# 55 Vastern Road, Reading, RG1 8QT

Statement of Common Ground between Berkeley Homes (Oxford and Chiltern) Ltd and Reading Borough Council Application Reference: 200188 Appeal Reference: APP/E0345/W/21/3276463

Fifth Addendum

November 2021

drawing number 448.PL.BC.111

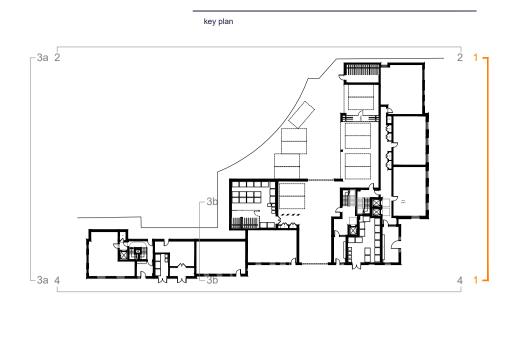
A 30.04.20. EE Removed balconies B 08.09.20. DT Cycle storage updated, added dormer on block C C 04.11.21. EE Roof Ventilation plan updated

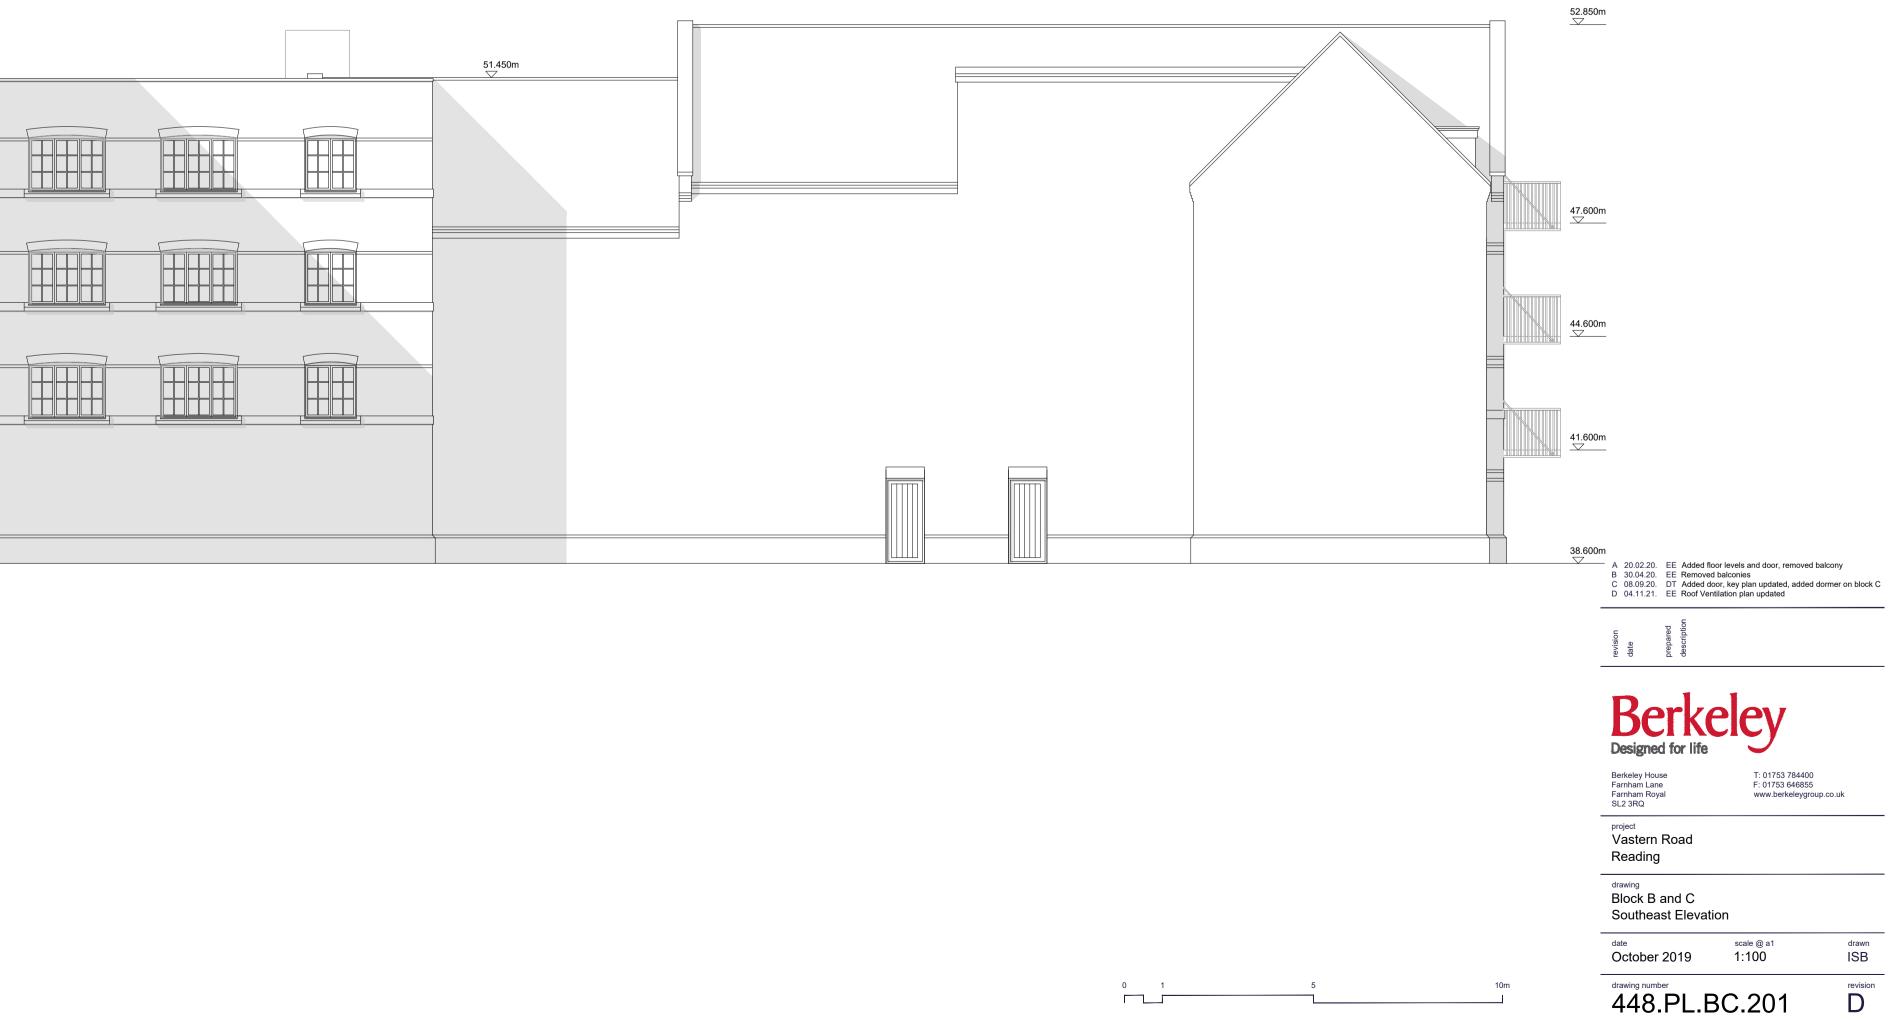
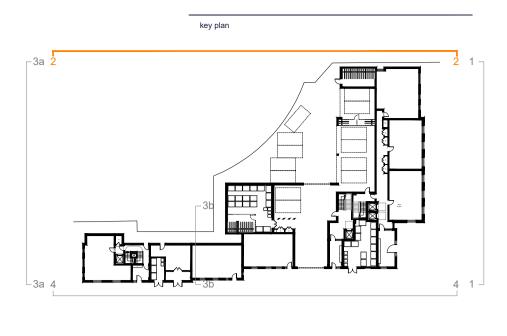
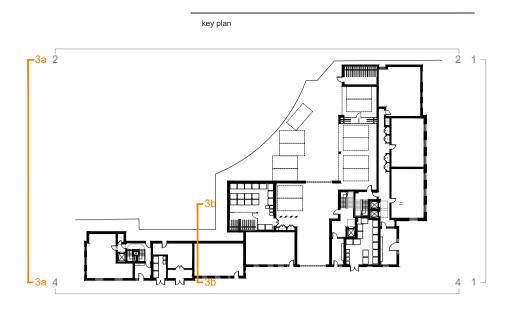
A 20.02.20. B 30.04.20. C 08.09.20. D 04.11.21.	EE Removed DT Key plan	balconies	
revision date	prepared description		
	d for life	eley	
Berkeley Hou Farnham Lan Farnham Roy SL2 3RQ	e	T: 01753 784400 F: 01753 646855 www.berkeleygroup	o.co.uk
<sup>project</sup> Vastern Reading			
drawing Block B Southwe	and C est Elevati	ion	
<sup>date</sup> October	2019	scale @ a1 1:100	drawn ISB
drawing numb		3C.200	revision

Triple Glazing: 9.5mm glass - 6mm airgap - 4mm glass -14mm airgap - 4mm glass Secondary Glazing: 200mm airgap - 8.8mm acoustic laminated glass Ventilation: All atmospheric termination on the roof. No atmospheric termination on the facade.

drawing number 448.PL.BC.300

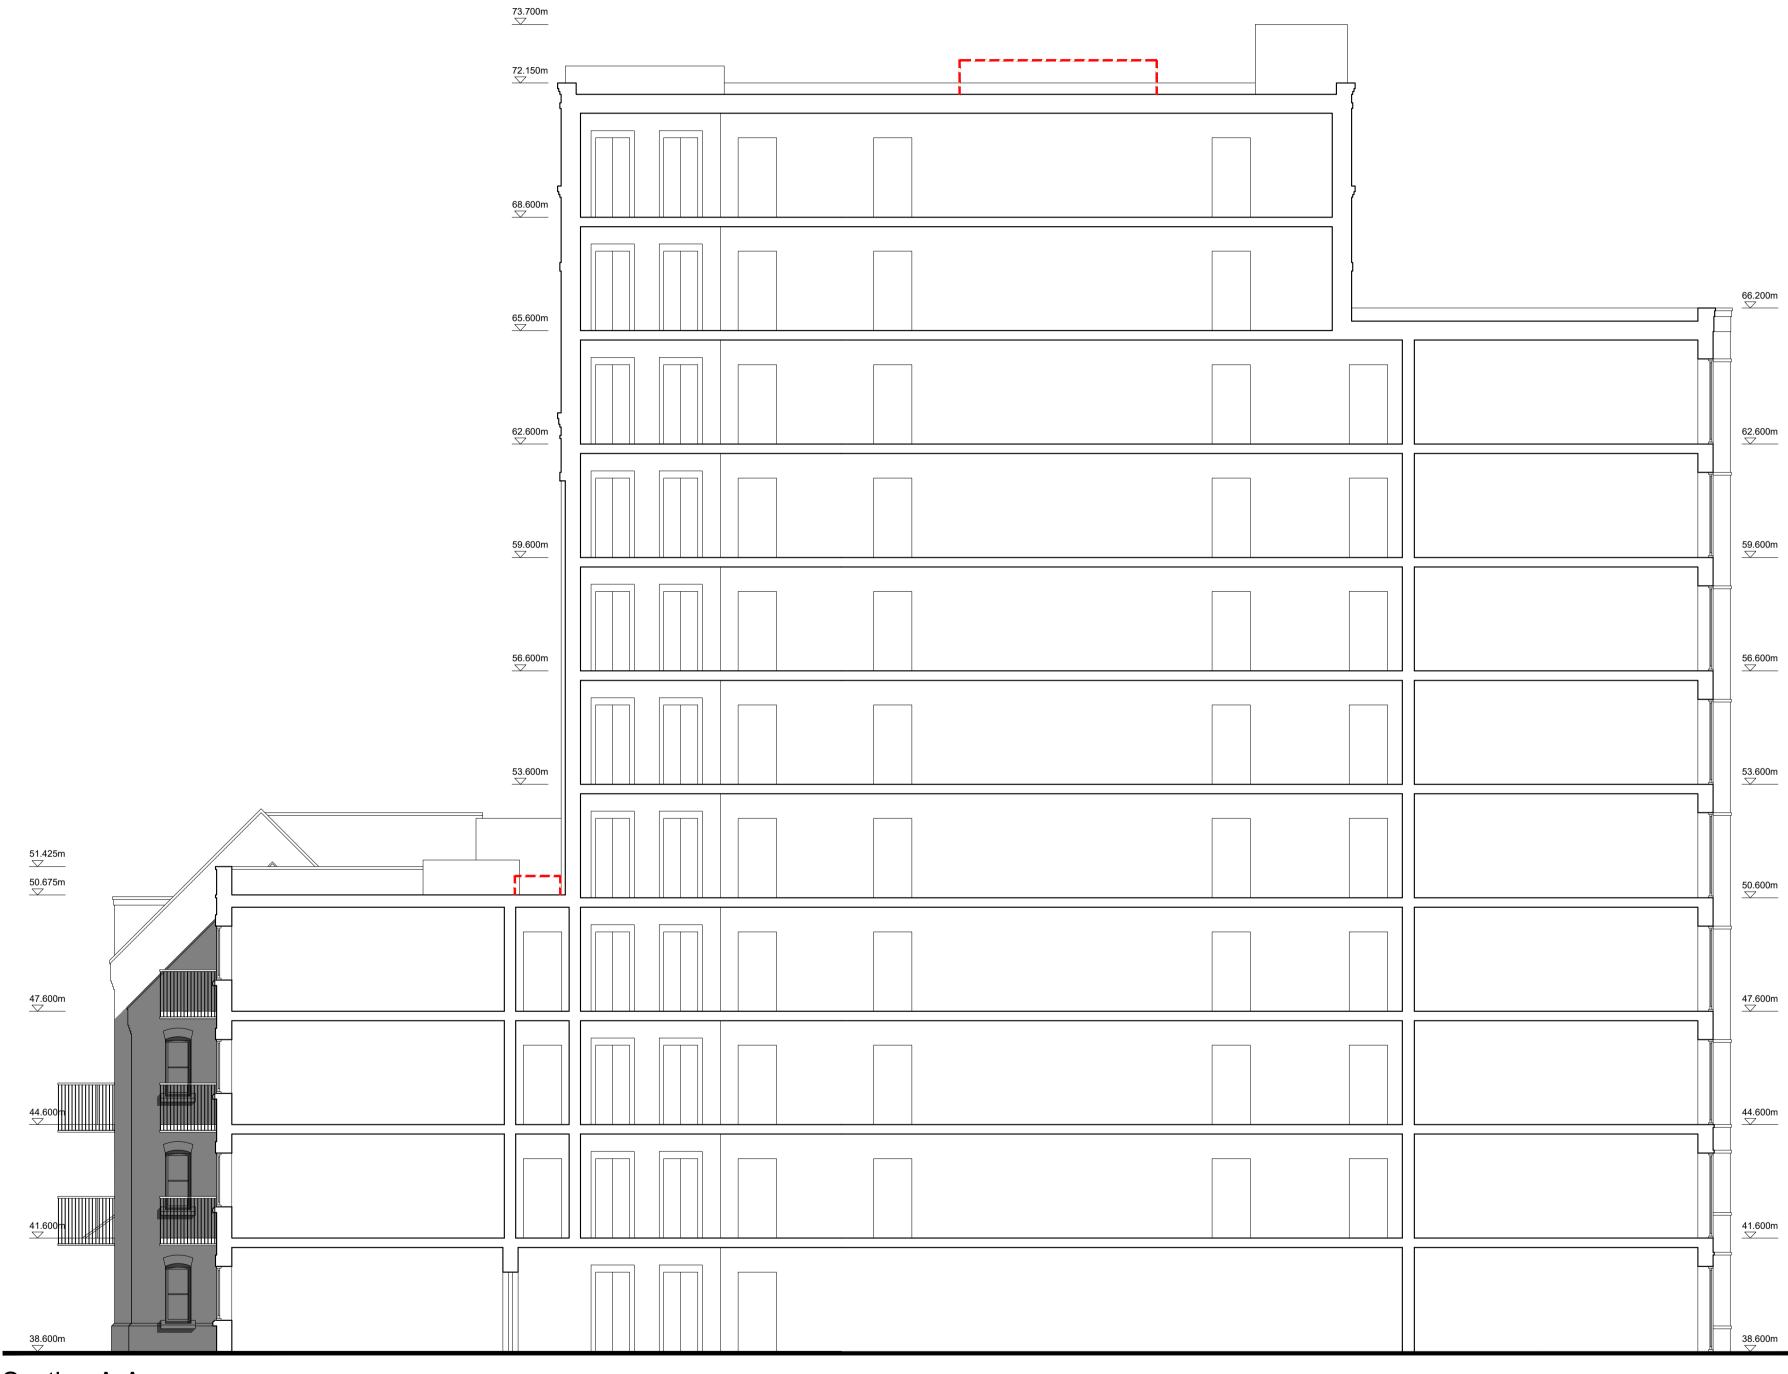
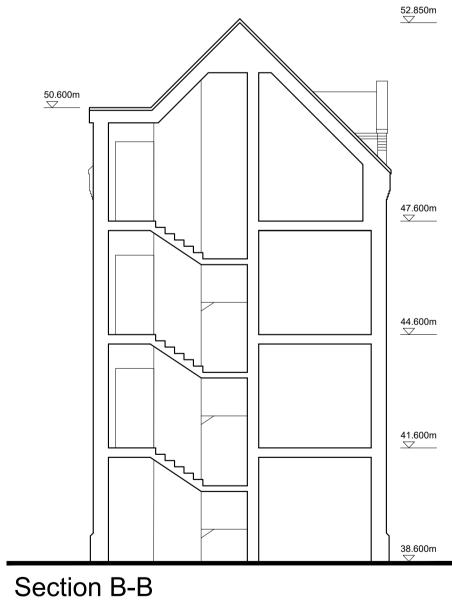
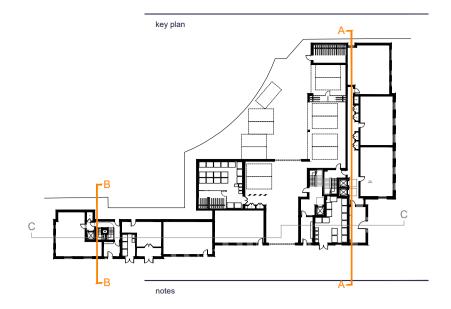
B 30.04.20. EE Remo C 08.09.20. DT Key p	d floor levels oved balconies olan updated Ventilation plan updated	
revision date prepared description		
Berkeley House Farnham Lane Farnham Royal SL2 3RQ		5
<sup>project</sup> Vastern Road Reading		
<sup>drawing</sup> Block BC Section A-A an	d B-B	
date October 2019	scale @ a1 1:100	drawn EE

drawing number / revised 448.PL.BC.V.111

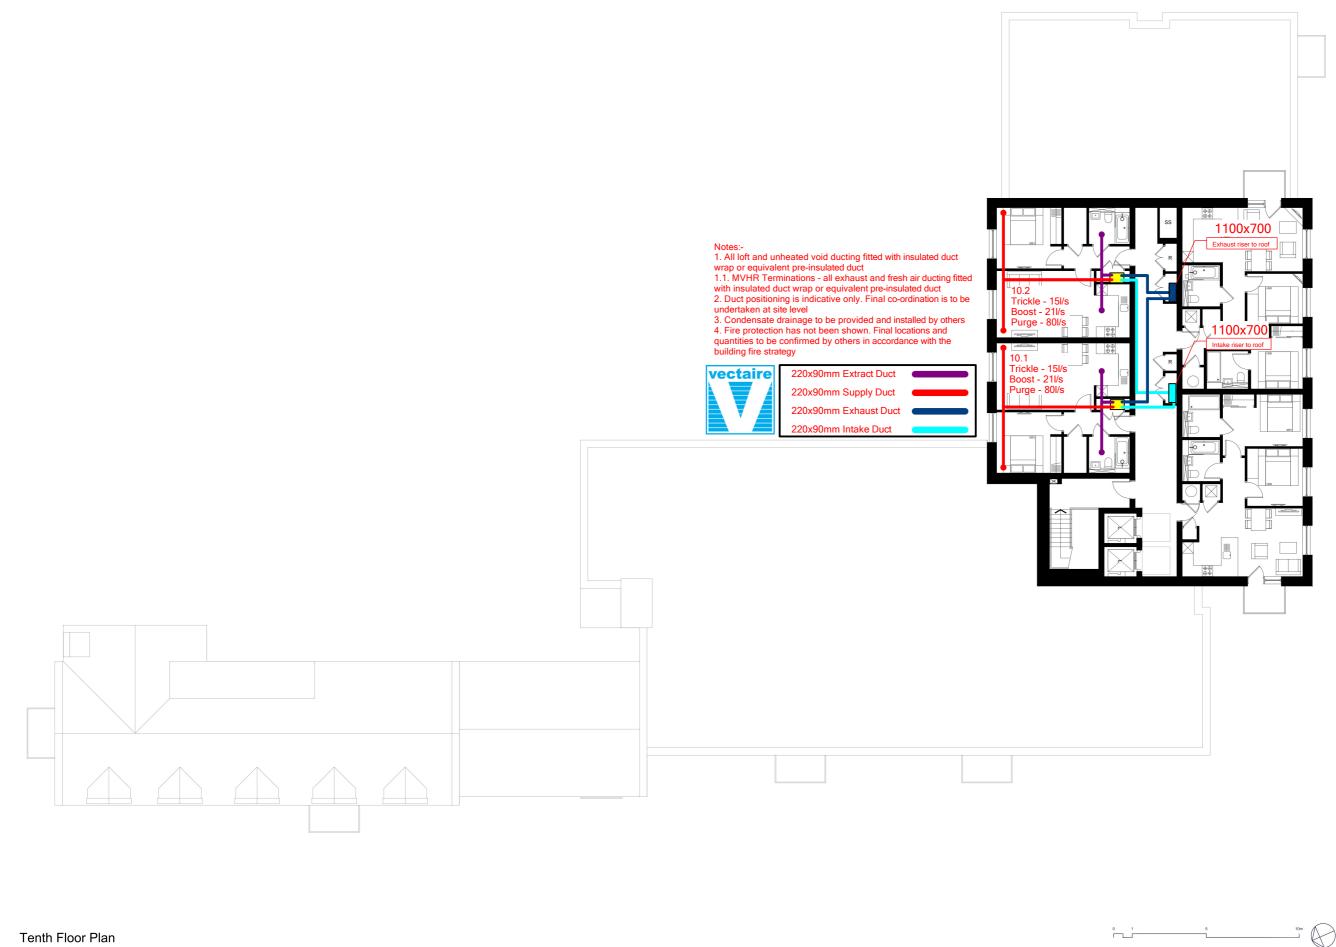
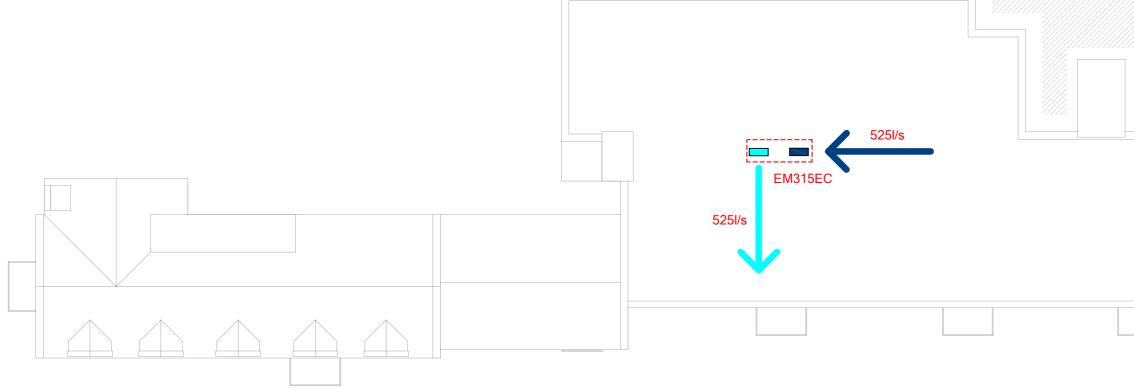
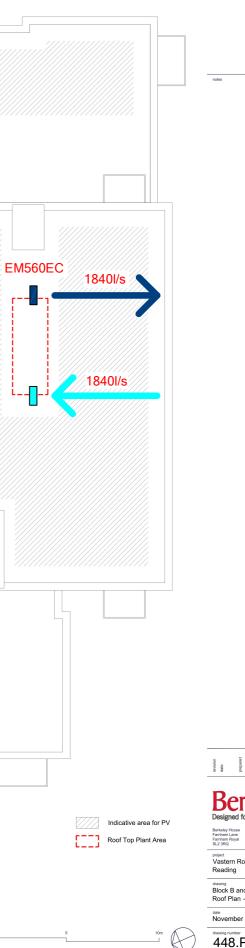
### Sound Power Levels of Roof Extract Units

Fan	Airflow	Pressure	63	125	250	500	1K	2K	4K	8K	(A)
EM 315 EC or equivalent specification	0.47 m3s-1	150 Pa	66	71	76	73	72	69	67	59	80
EM 560 EC or equivalent specification	1.64 m3s-1	100 Pa	65	68	68	70	72	69	65	58	77
	Nearest Du	In Duct Outlet Sound Power Level (dB) ref 1 x 10-12 watts

Attenuator	Length	Airways	63	125	250	500	1K	2K	4K	8K
EEC AS40 or equivalent specification	1,800mm	150mm	5	12	23	41	44	35	23	15

Attenuator	Length	Airways	63	125	250	500	1K	2K	4K	8K
SILL204 or equivalent specification	50mm?		6	8	14	25	39	48	50	41

Flow rates shown assume approx. a max. 80% of apartments using purge simultaneously
